HISTORIC PRESERVATION BOARD

HISTORIC PRESERVATION BOARD MEETING

**PUBLIC HEARING
FIRST PARISH CHURCH, 425 CONGRESS STREET**

TO: Chair Sheridan and Members of the Historic Preservation Board
FROM: Deb Andrews, Historic Preservation Program Manager
DATE: April 29, 2020
RE: May 6, 2020 **PUBLIC HEARING**

1 ROOF DECK FLOOR PLAN
1/4" = 1'-0"

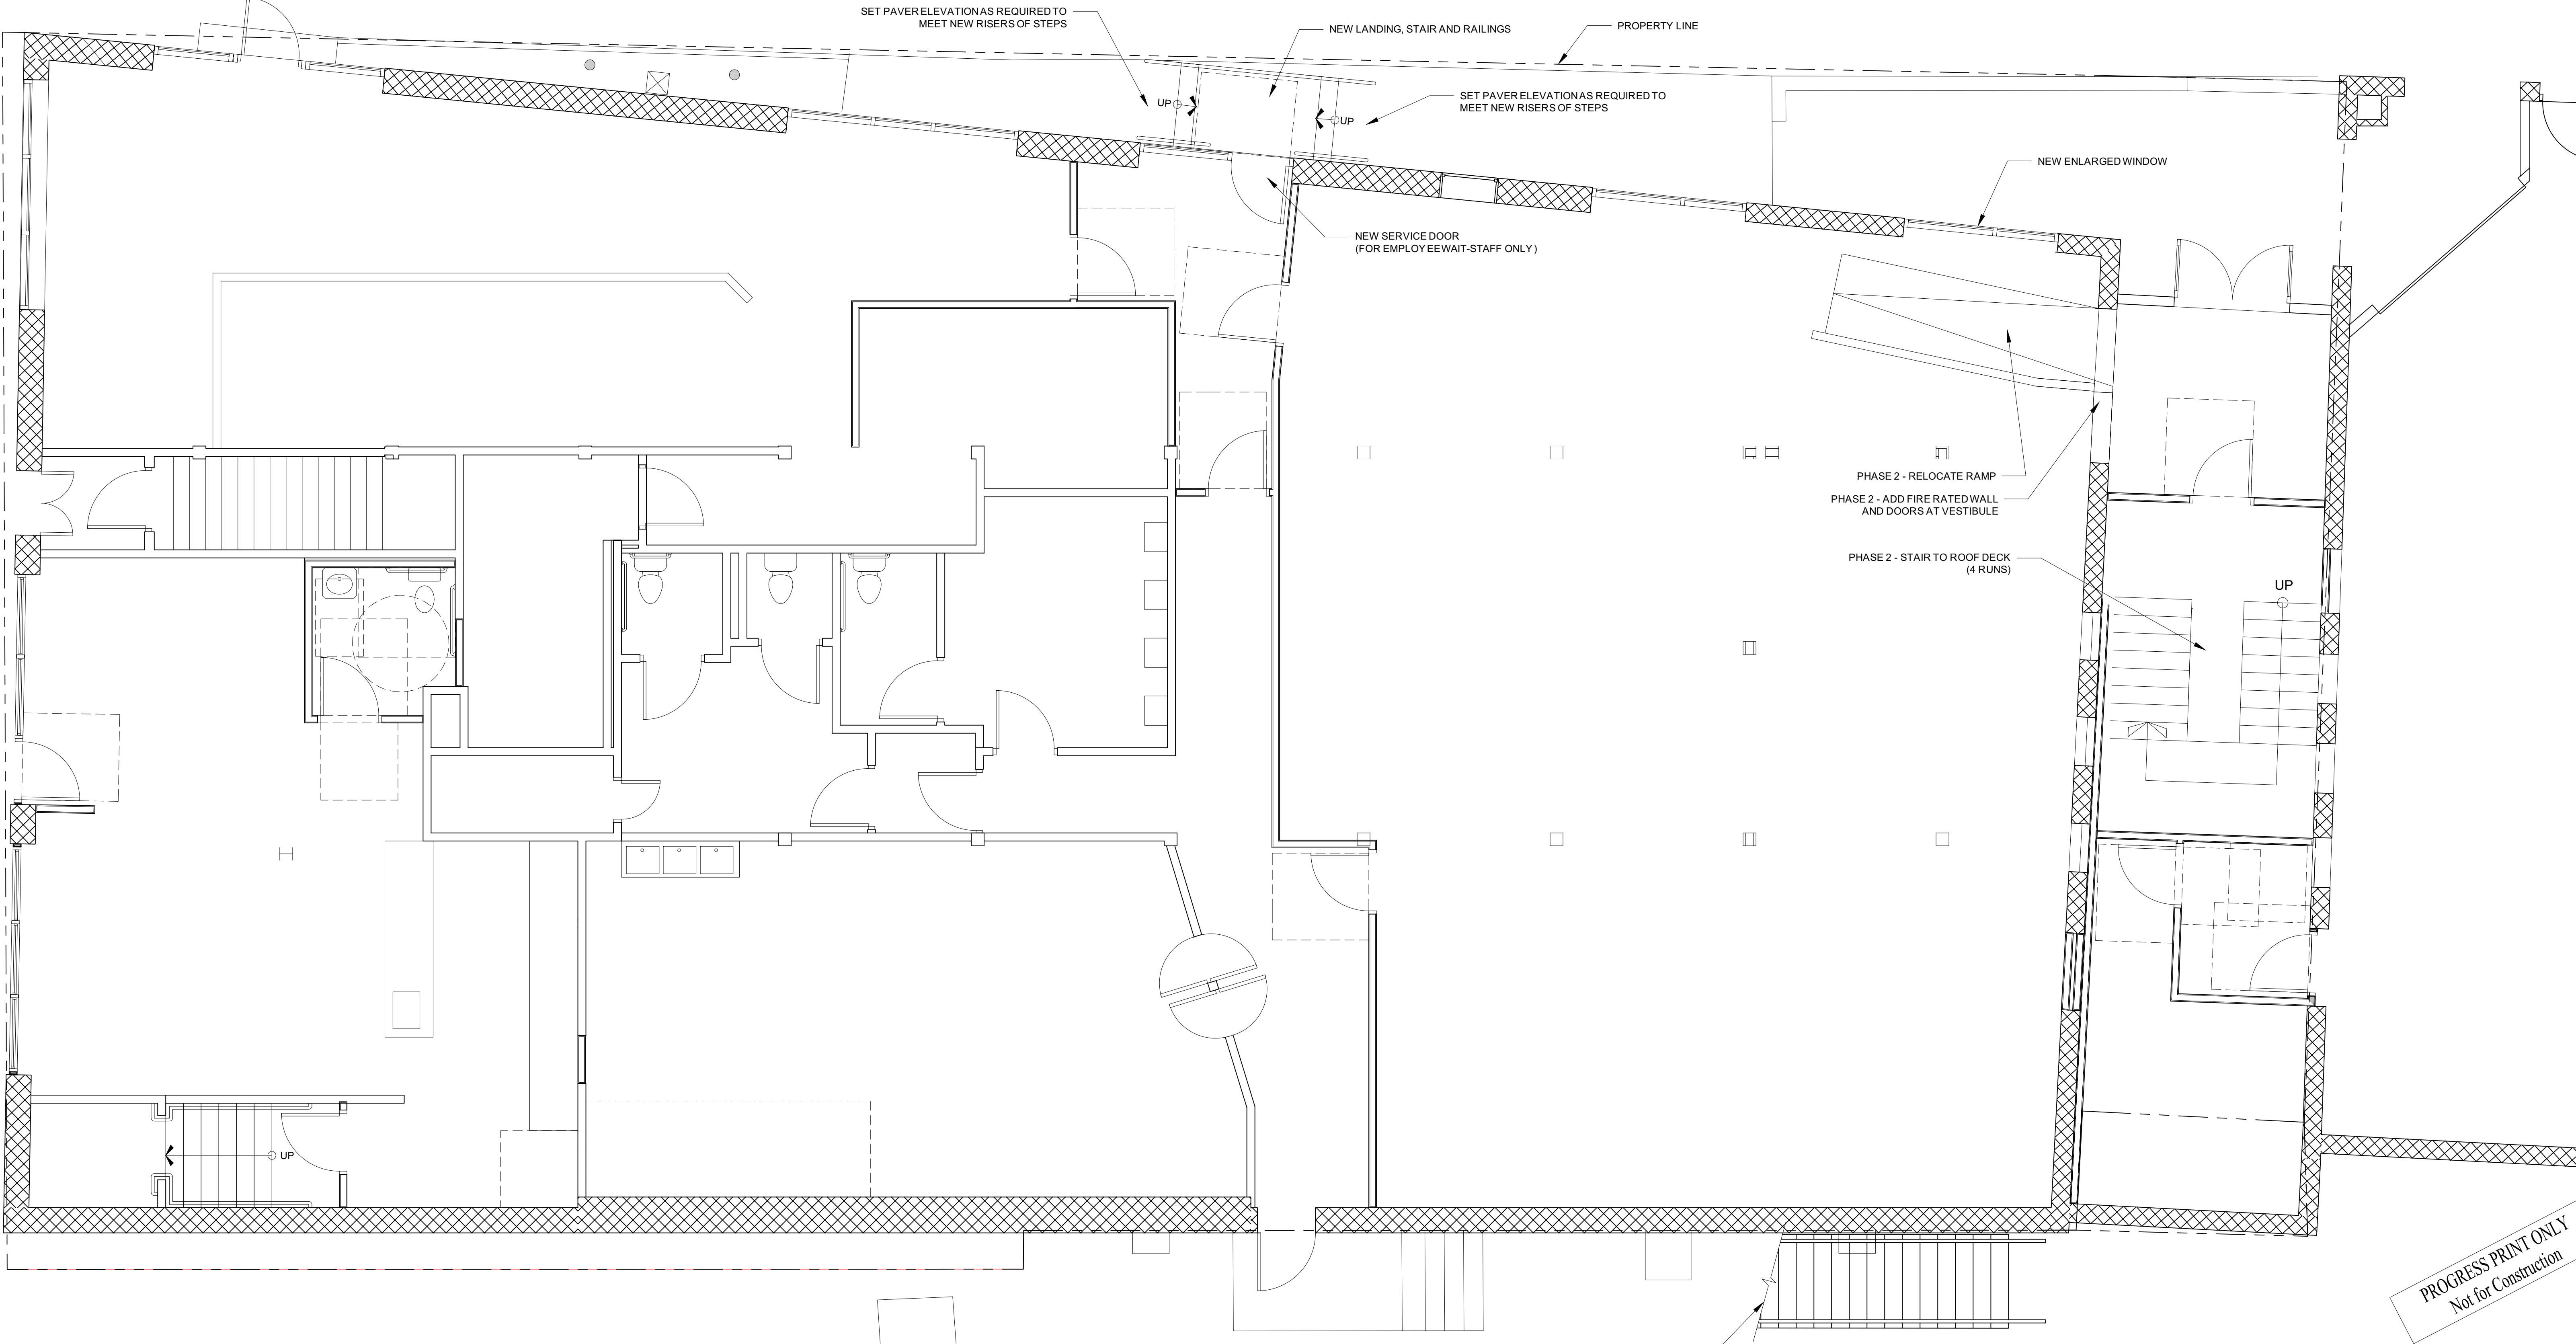
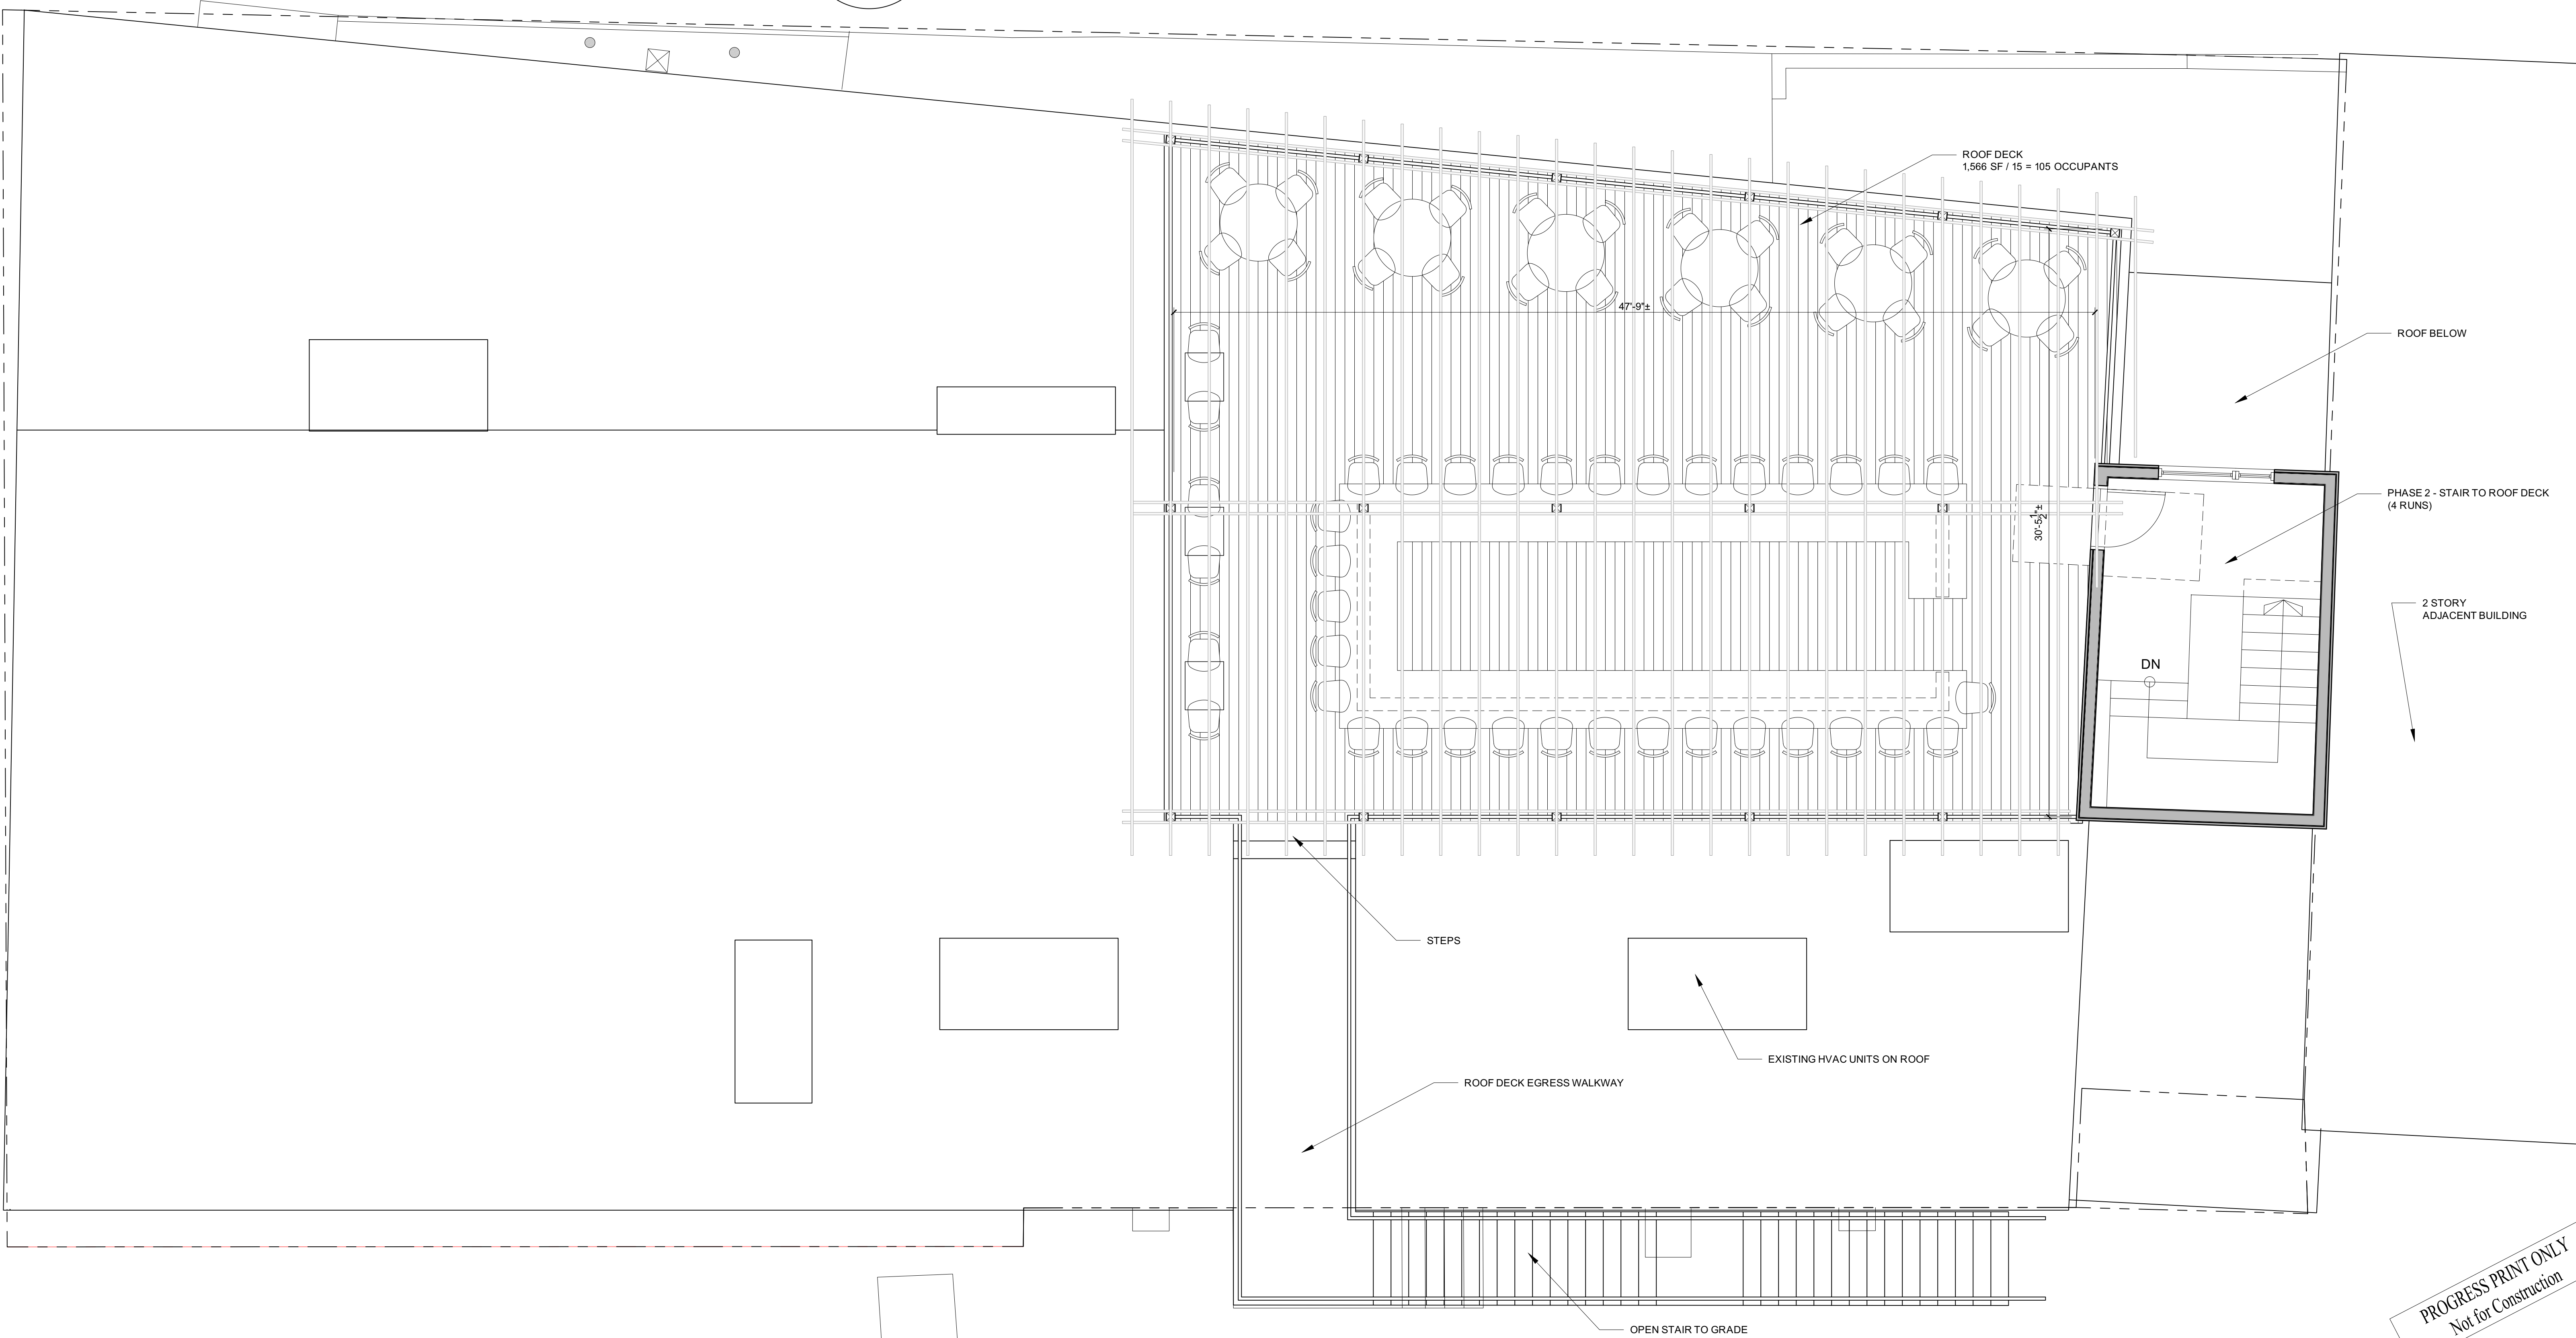
- On the plans the enclosed stairs are marked "Phase Two." Will the applicants explain the phasing plan at the workshop?
- Staff notes there appear to be no plans to make the new roof deck accessible.

2 WHARF STREET (NORTH) EXTERIOR ELEVATION
1/4" = 1'-0"

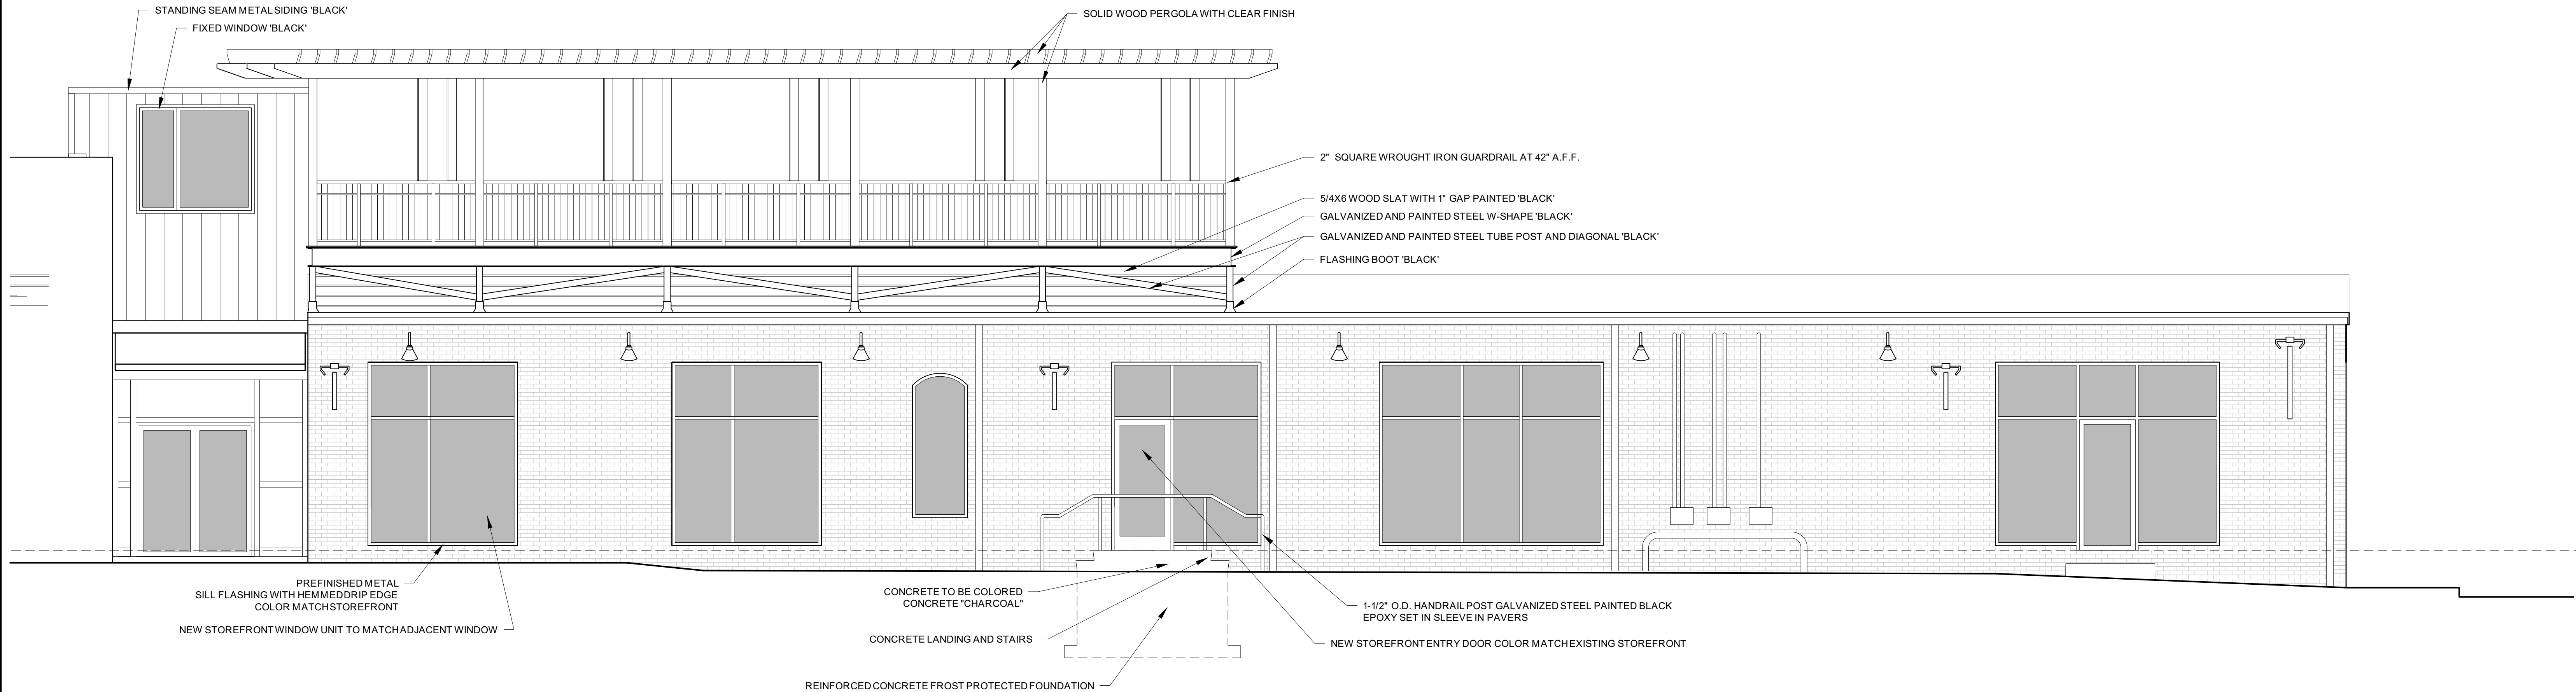
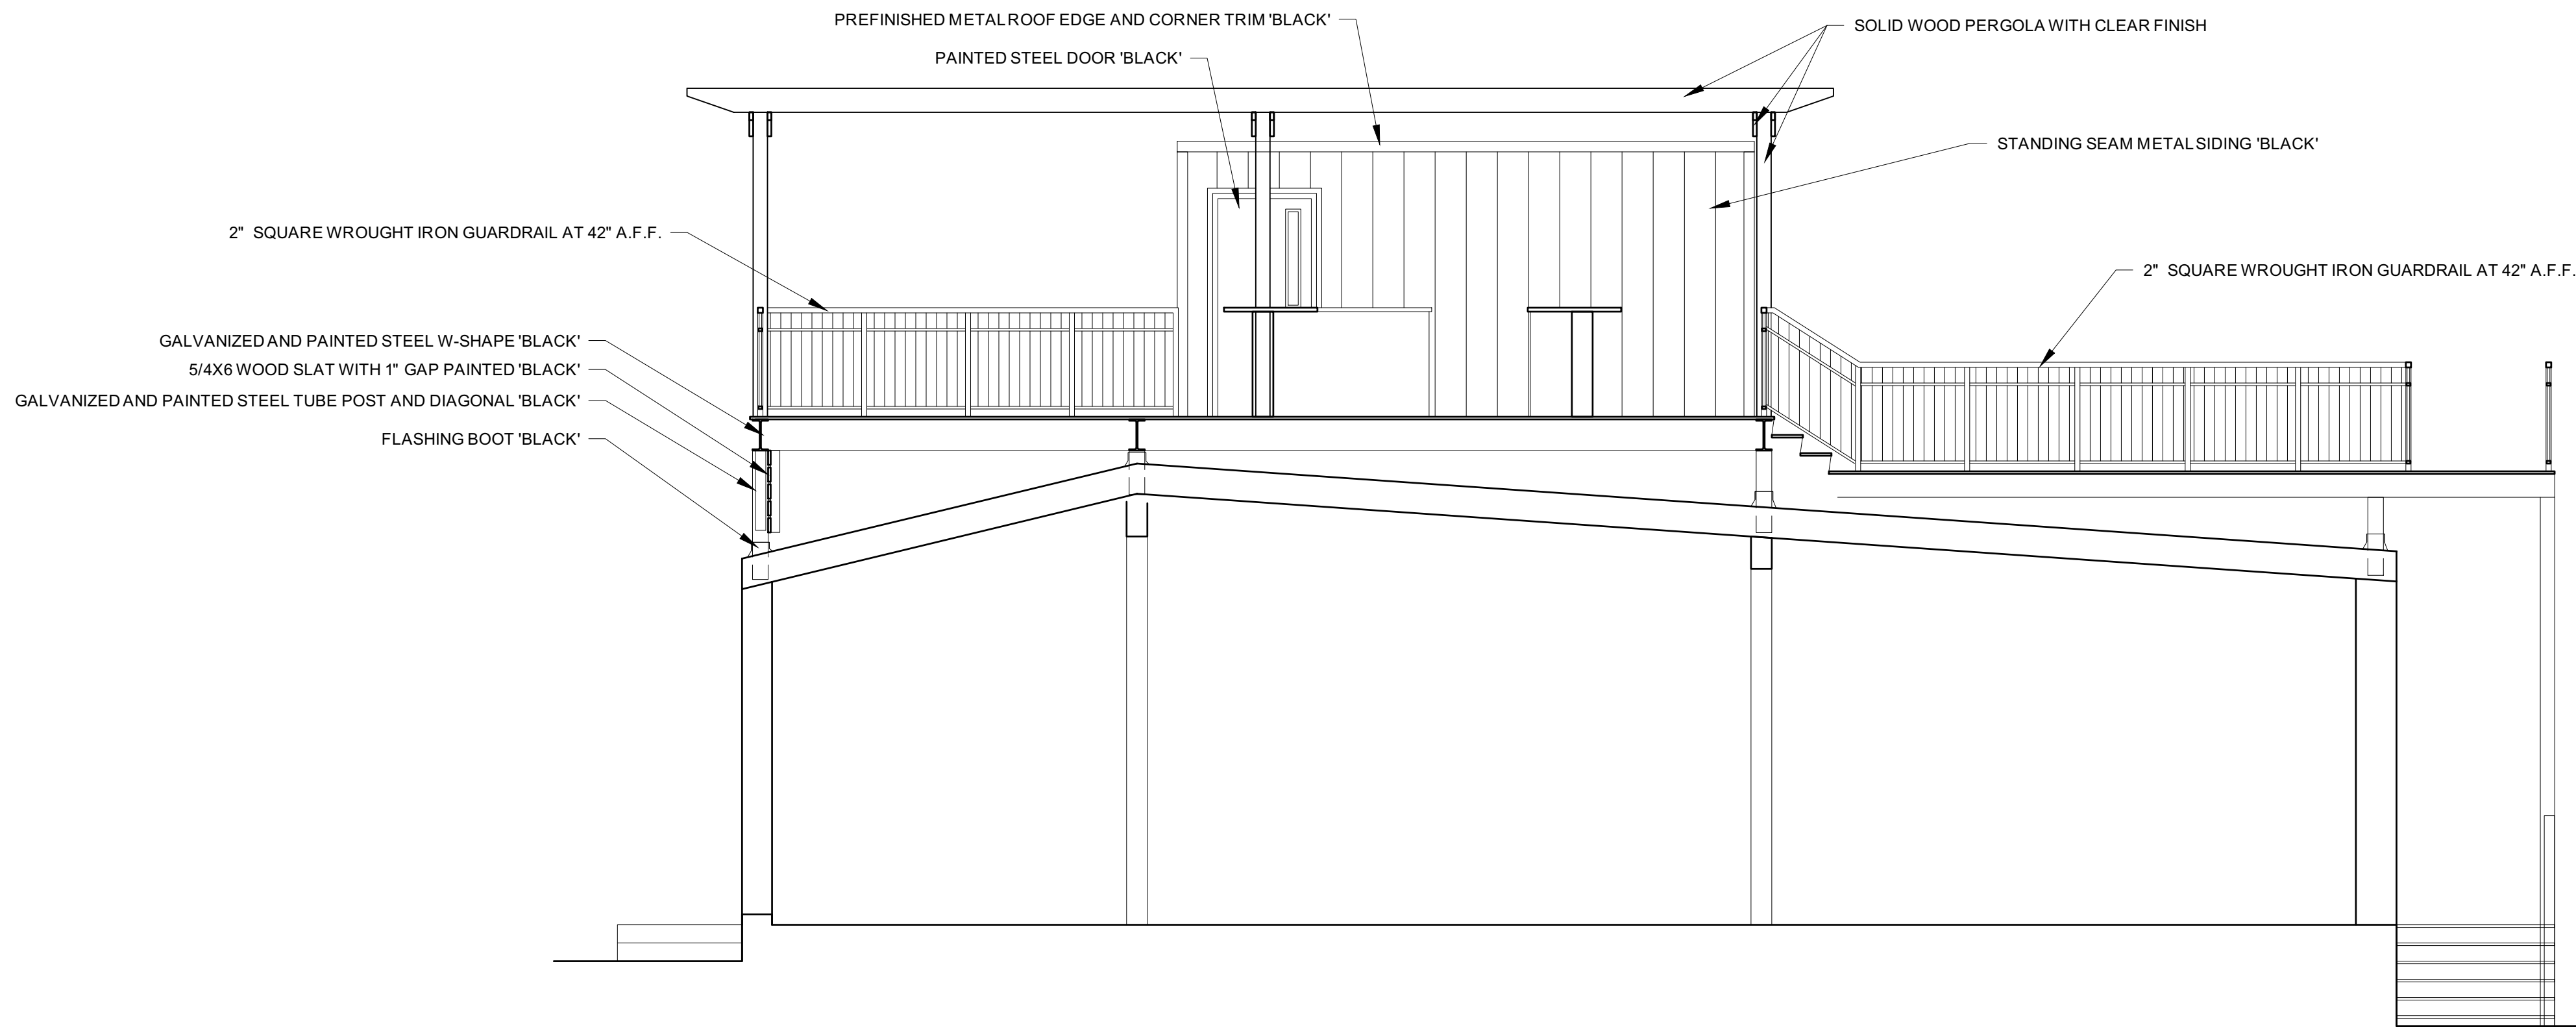
Note that the architect's submittal does not include an elevation drawing of existing conditions. The Board will need to compare the photos of existing conditions with the proposed elevation.

- A more detailed rendering or elevation would be useful to fully show the relationship between the new stair tower, pergola, and the historic but eclectically altered building immediately to the east.
